RE: Circle Oak Manford Boulevard Variance
Figure 10.7-MEDIAN LENGTH AND OPENING – Minimum Median Length A, B for Major
Thoroughfare and Major Thoroughfare
LJA Job No. 2198-2102 (6.1)

MANFORD BOULEVARD
MEDIAN VARIANCE EXHIBIT
SCALE: 1"=100'

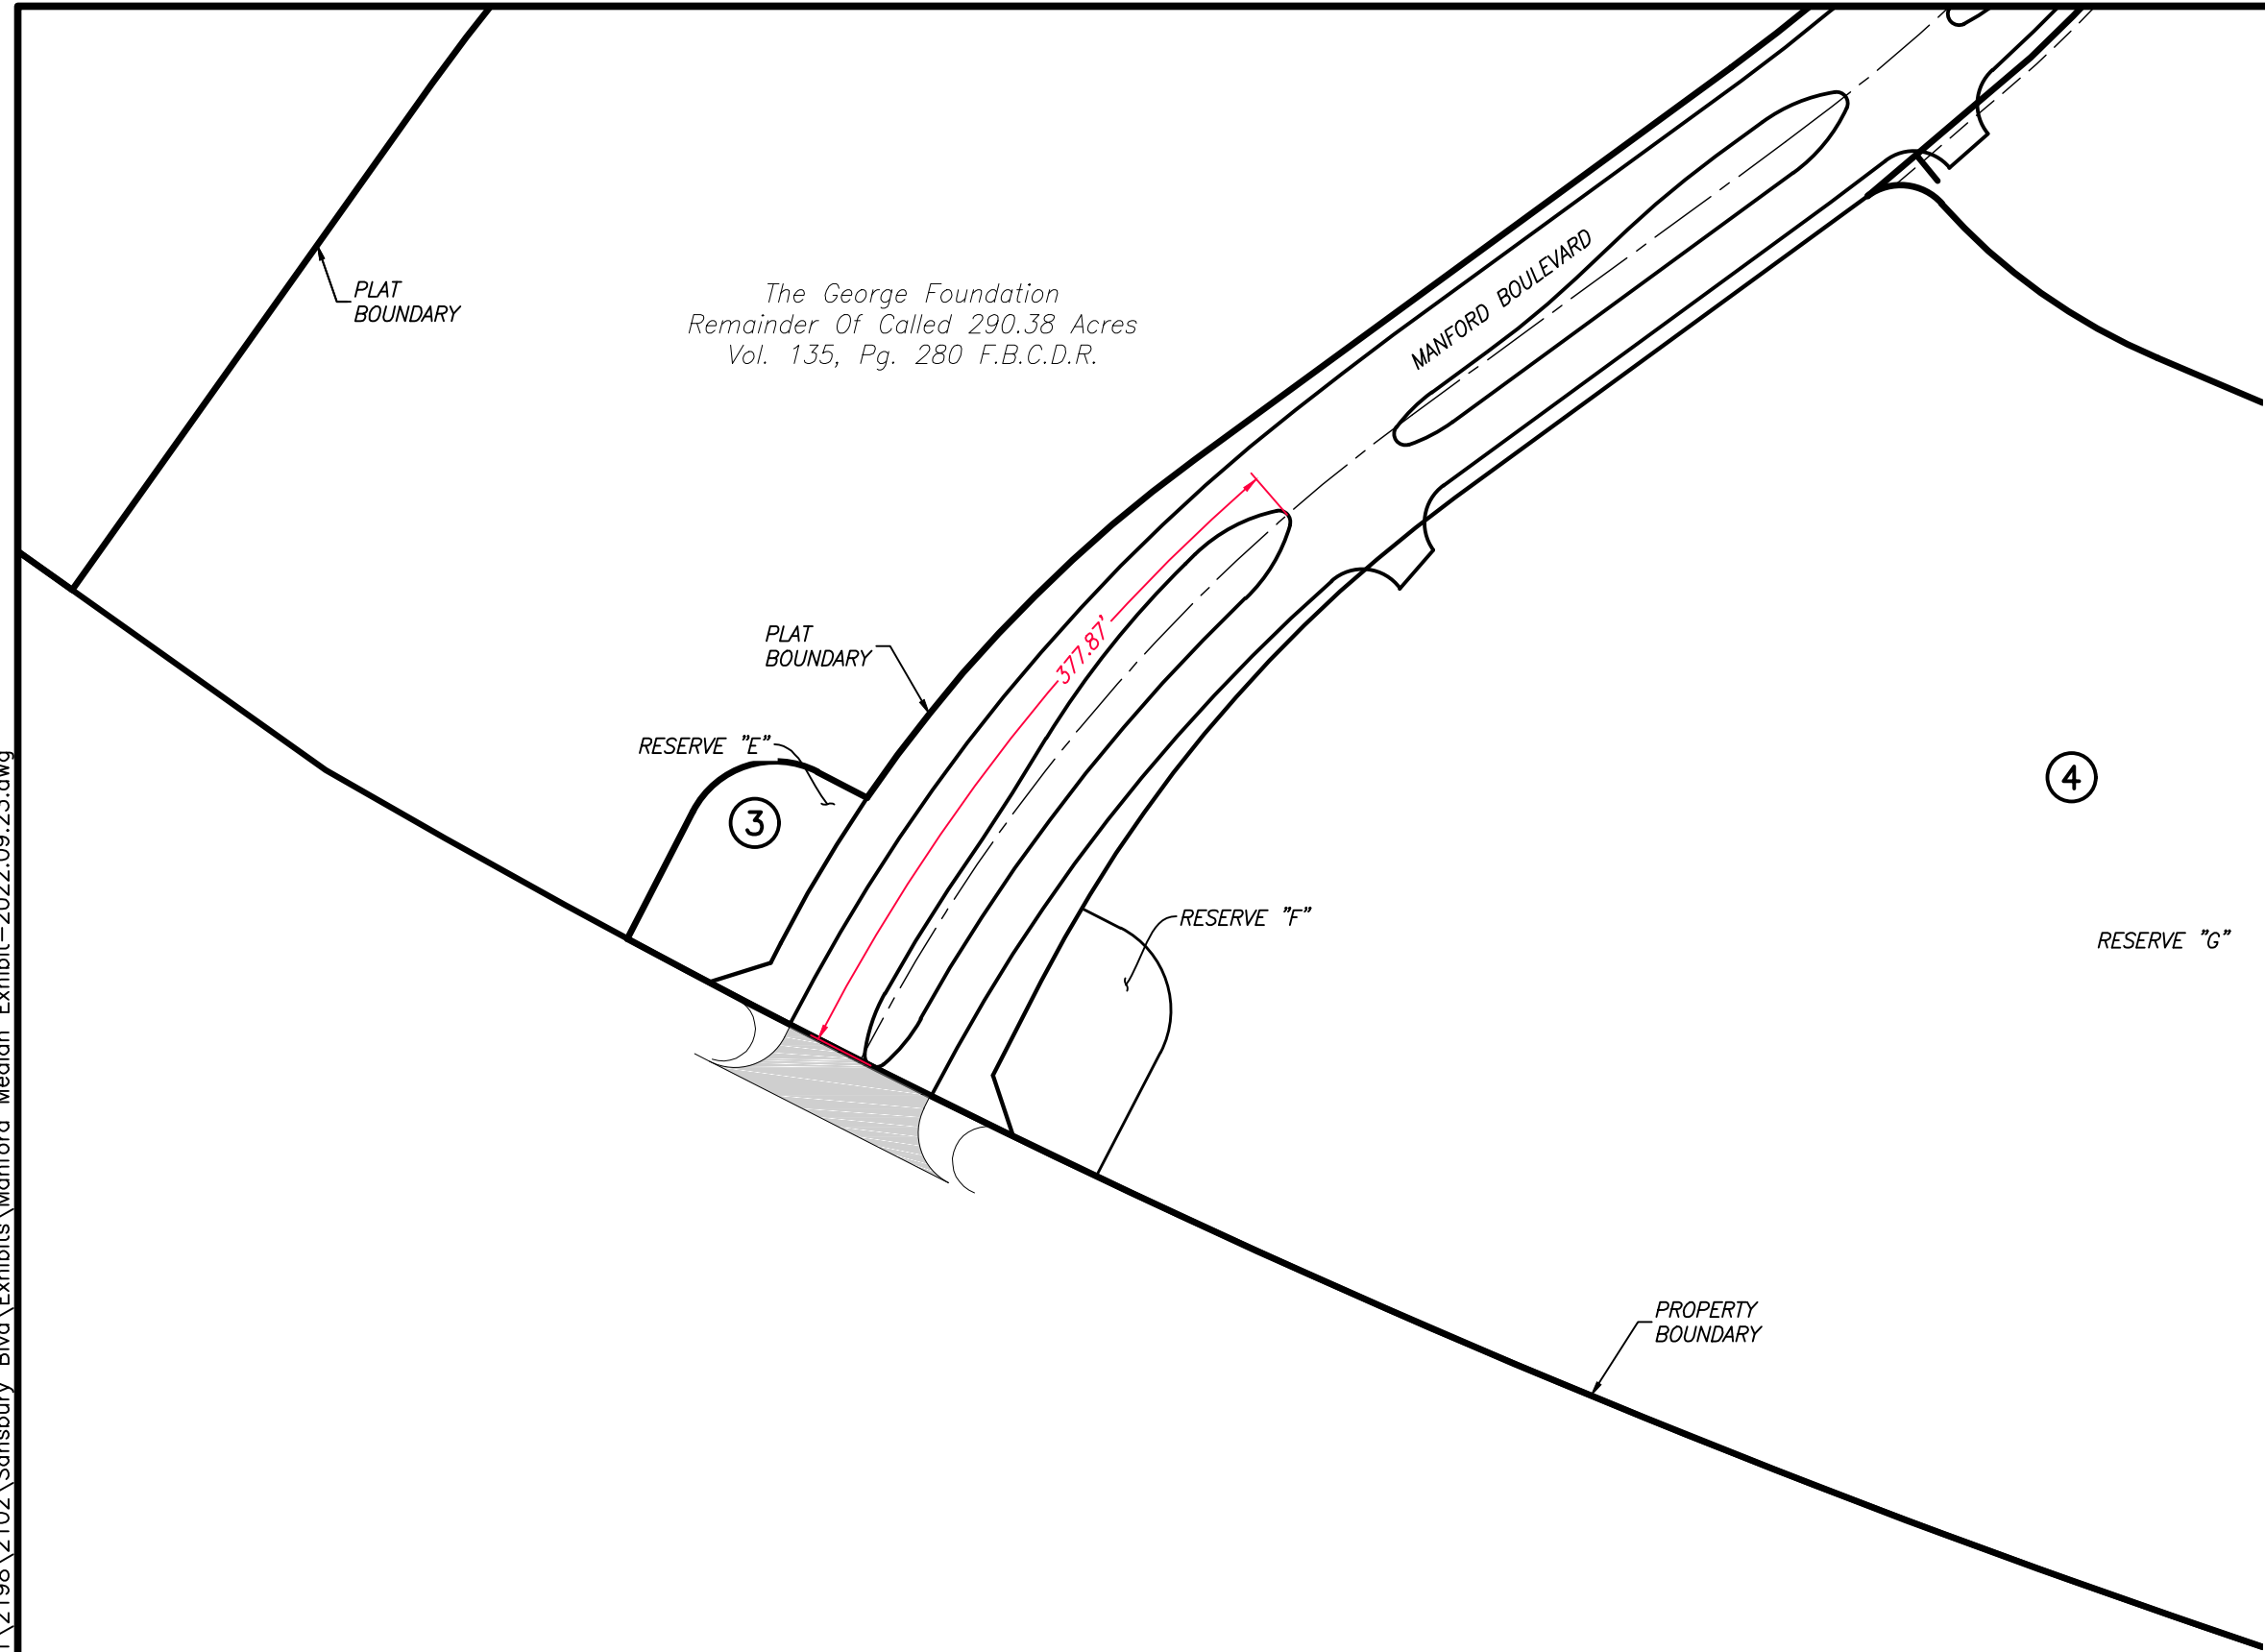
We are seeking a variance from Figure 10.7- Minimum Median Length of the City of Houston Infrastructure Design Manual due to proposed Manford Boulevard medians being less than 500 feet. We are proposing the median to be 378 feet to maintain a point of access traveling south bound along Manford, which will allow two points of access to the proposed apartment complex; one from Manford Boulevard and one from Murphy Jones Lane. The approval of this variance would allow for the fire code to be met for the proposed apartment complex. Please let me know if you have additional questions or comments.
